STAFF REPORT 12-9-2020 REGULAR MEETING

APPLICATION NUMBER: 20-6968

ADDRESS: 691 W. ALEXANDRINE STREET

SCOPE: REHABILITATE EXISTING BUILDING; ERECT NEW BUILDING

LANDSCAPE PLAN

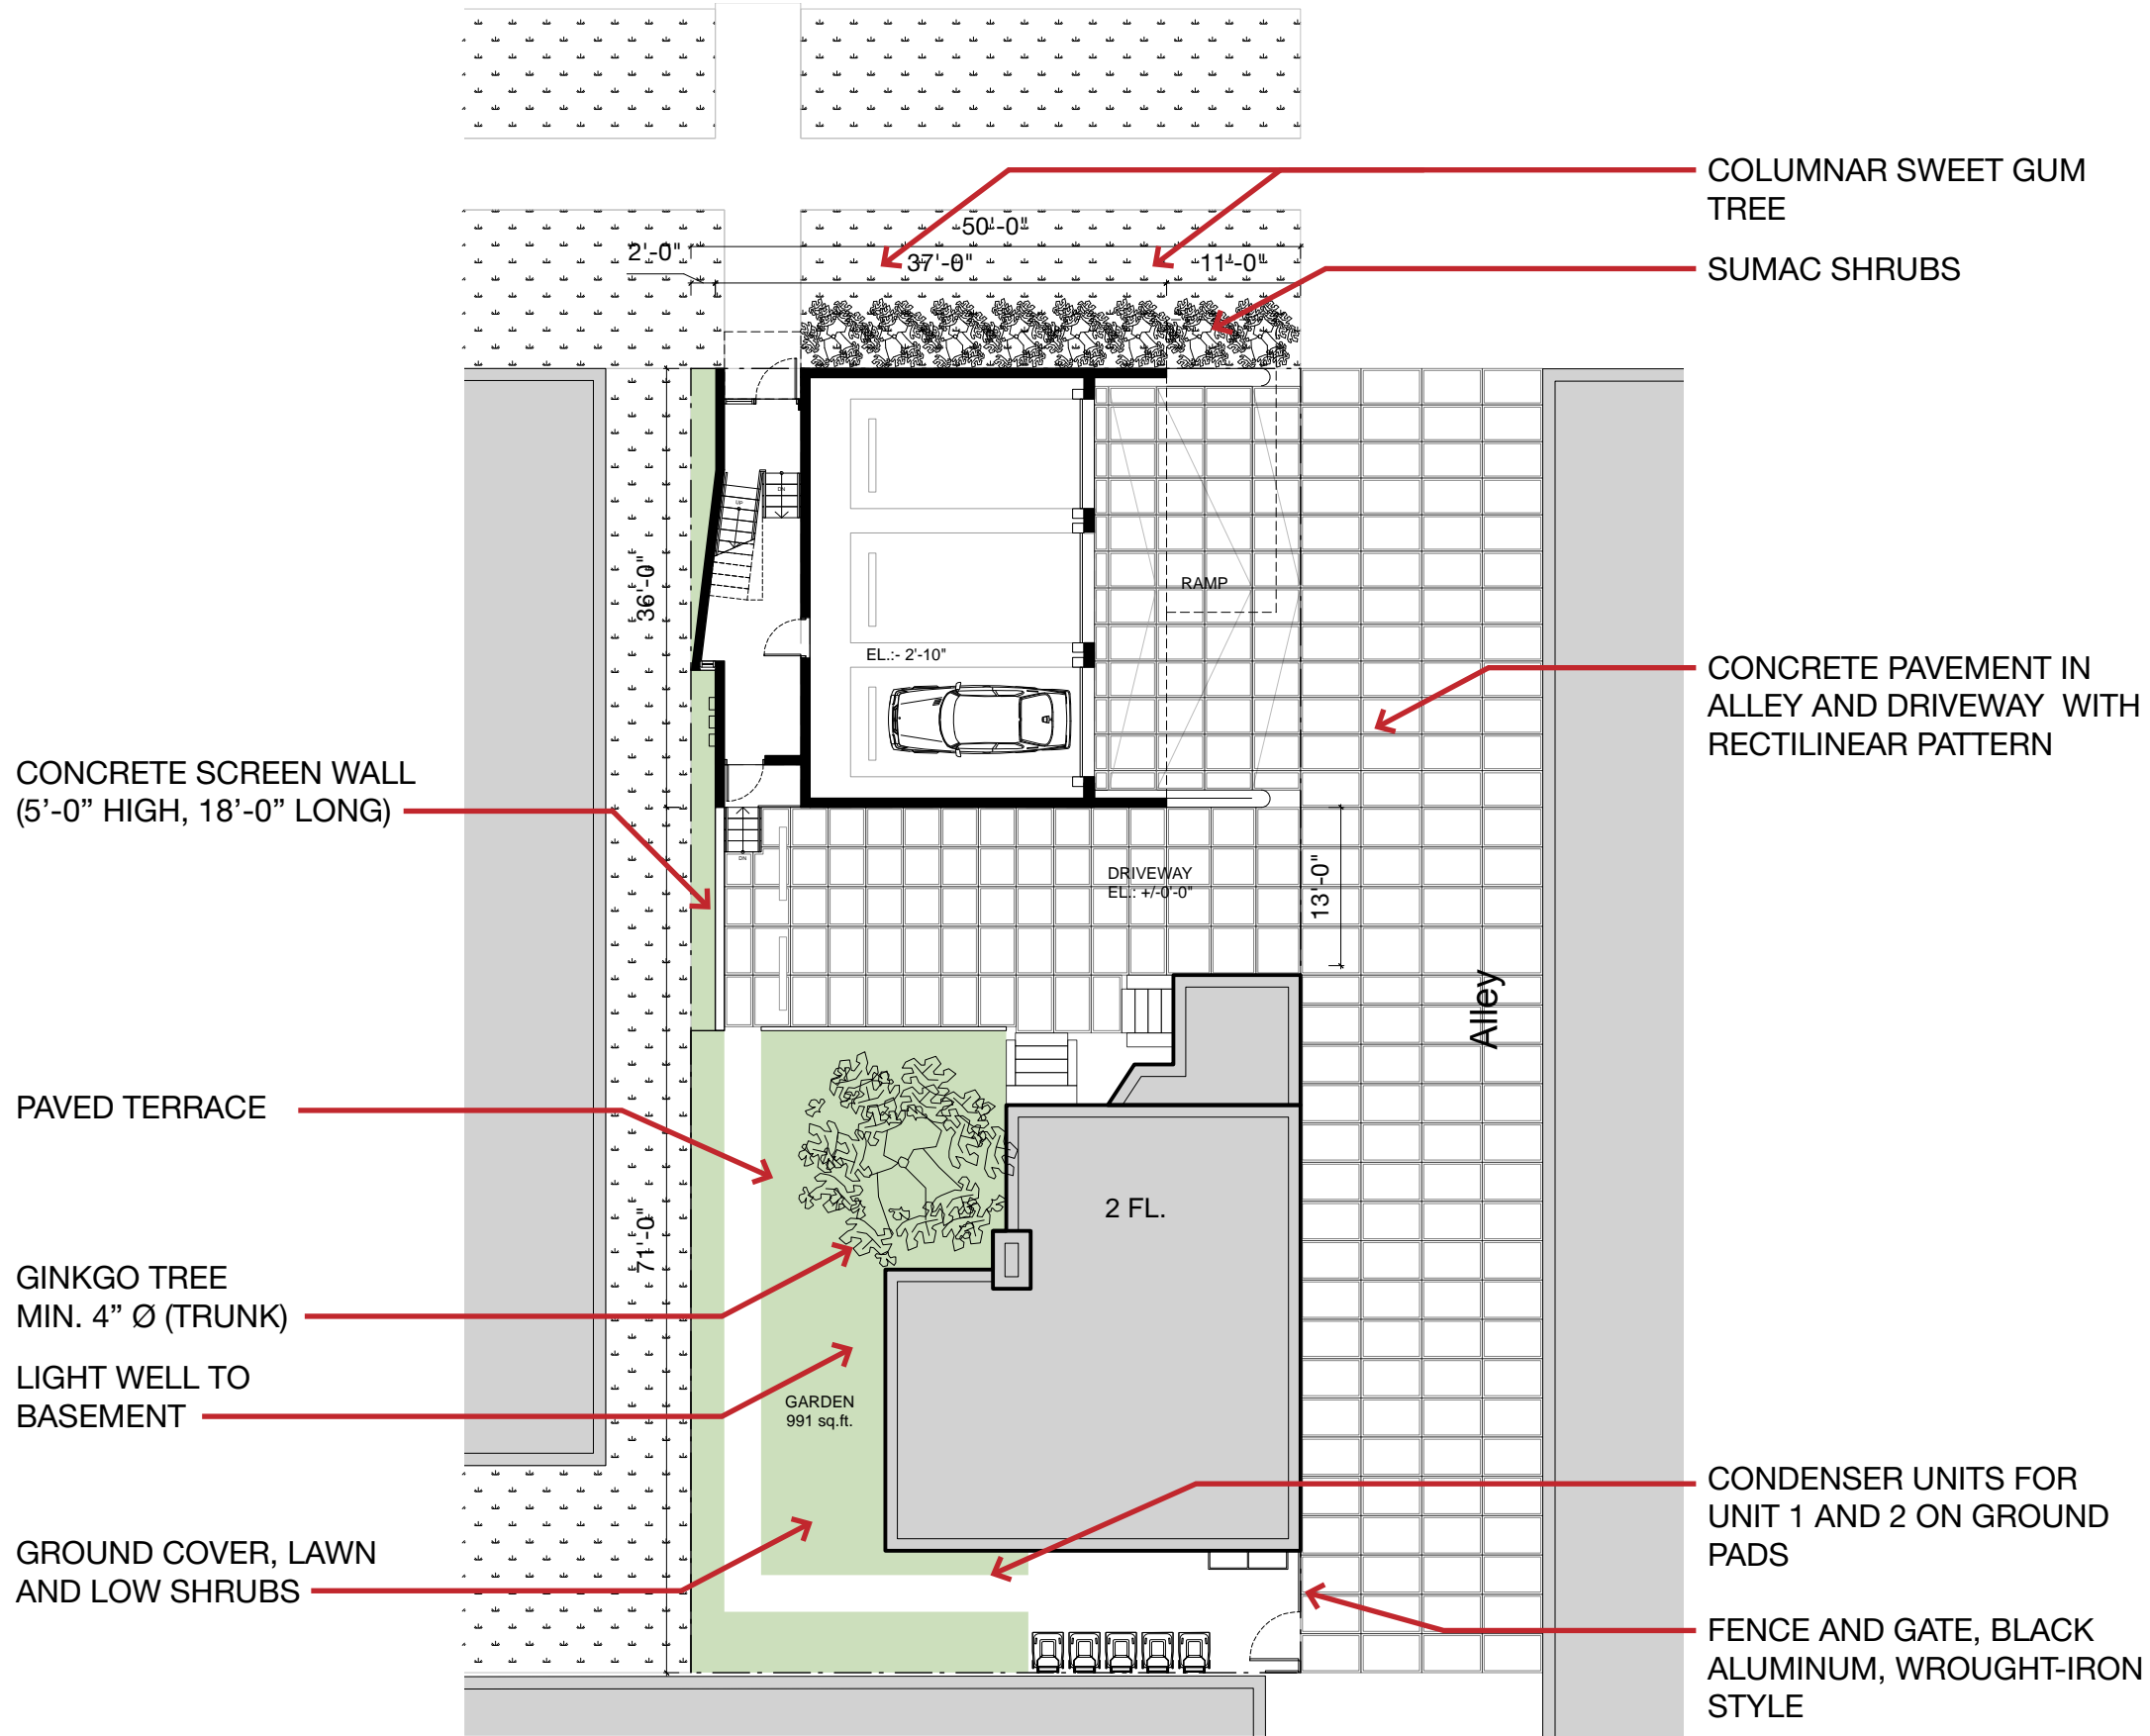
- **Concrete paving** – The proposed area of concrete paving is very large and not appropriate for the character of the property. Consider reducing the amount of impervious paving or incorporating permeable paving.

- The existing original wood windows are to be repaired and restored rather than replaced. In the case of non-historic windows such as existing vinyl replacements, or where sashes are missing, the replacement windows are to match the existing [historic wood windows \(added to report 12/9/2020\)](#) in material, profile design, operation, light configuration, and finish.
- Implement "The Black Box" balcony design option on the new building.
- Utilize a regular fenestration pattern on the new building.
- Reduce the amount of concrete paving proposed and/or utilize permeable paving.

ELEVATIONS / WINDOW SCHEDULE

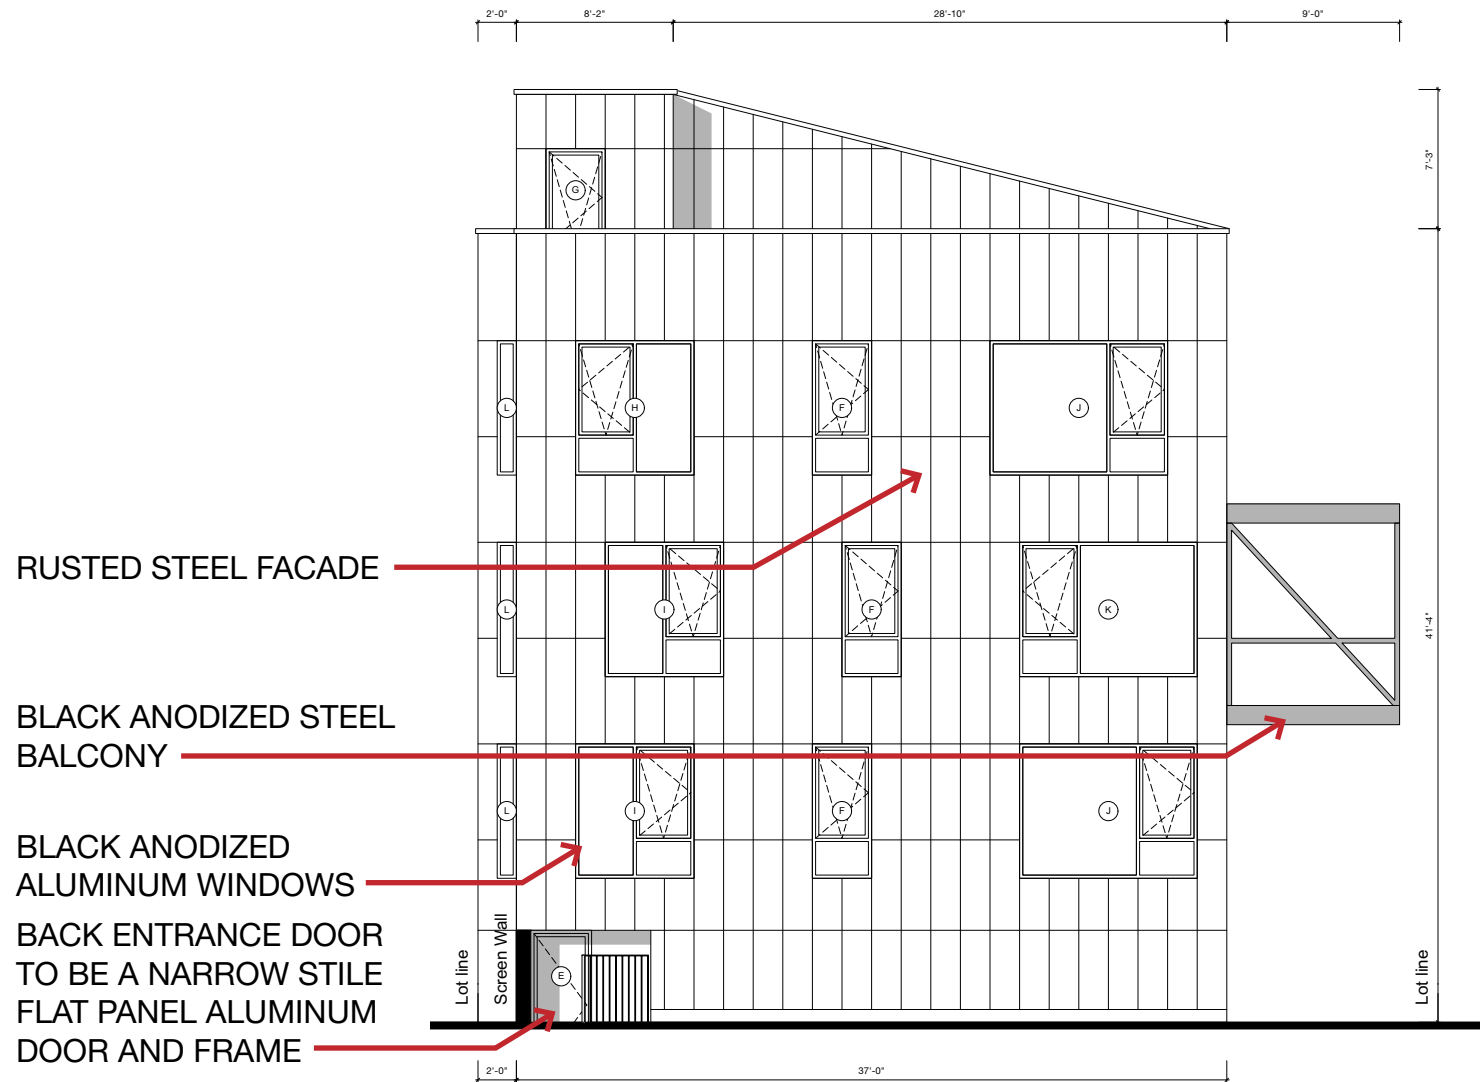
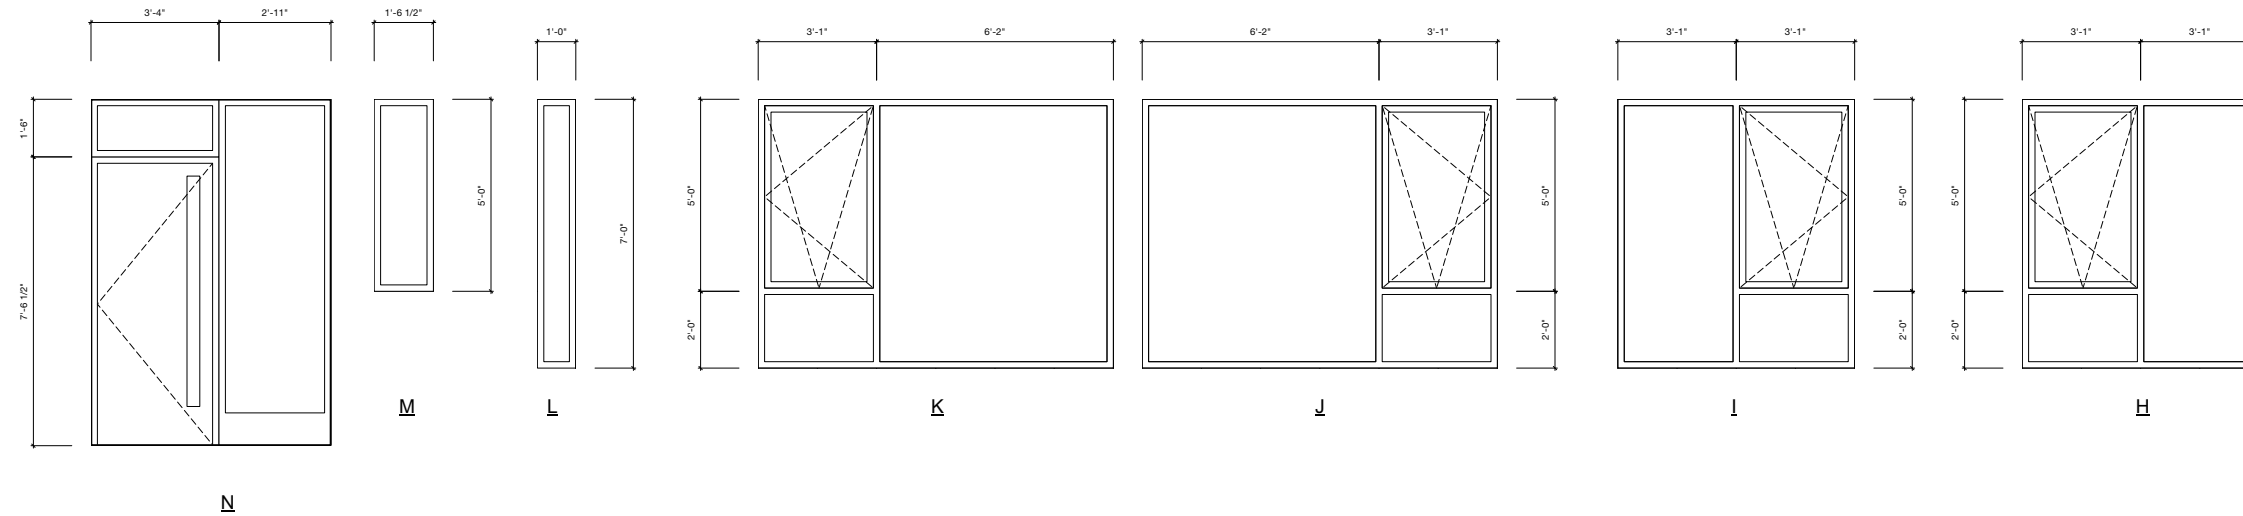
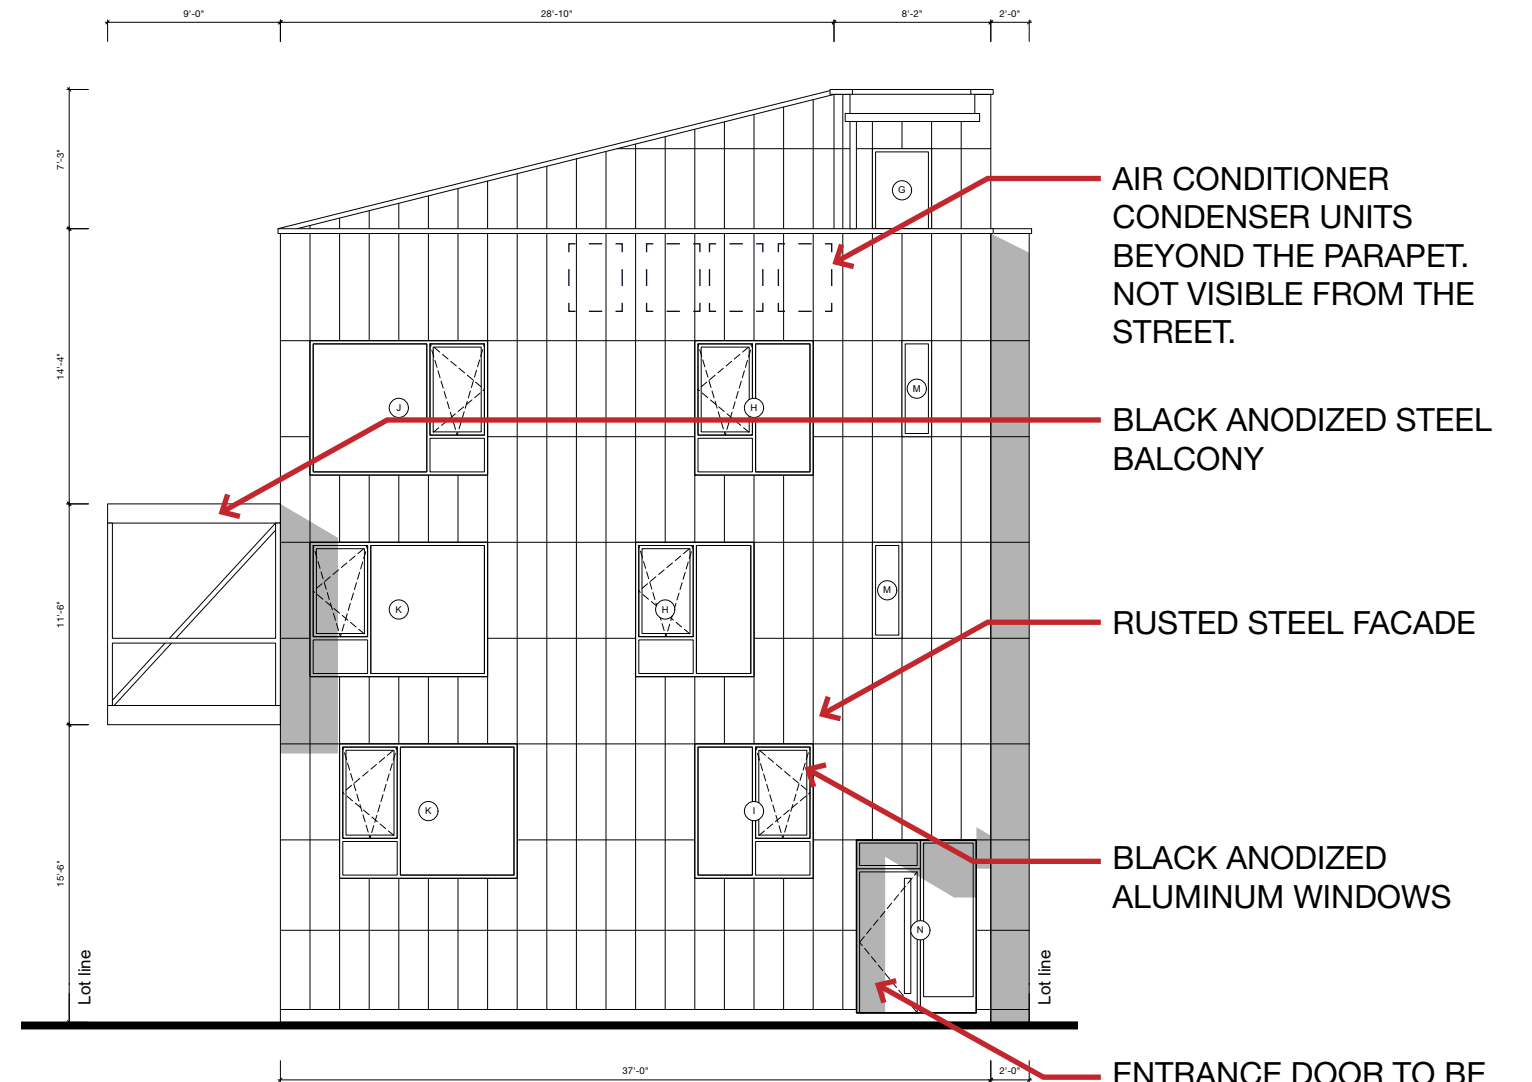
- **Window openings** – Rather than an irregular fenestration pattern (overly and unnecessarily complex), utilize a regular fenestration pattern similar to the adjacent apartment buildings. This will allow the detail of the balcony and the front entrance to stand out.
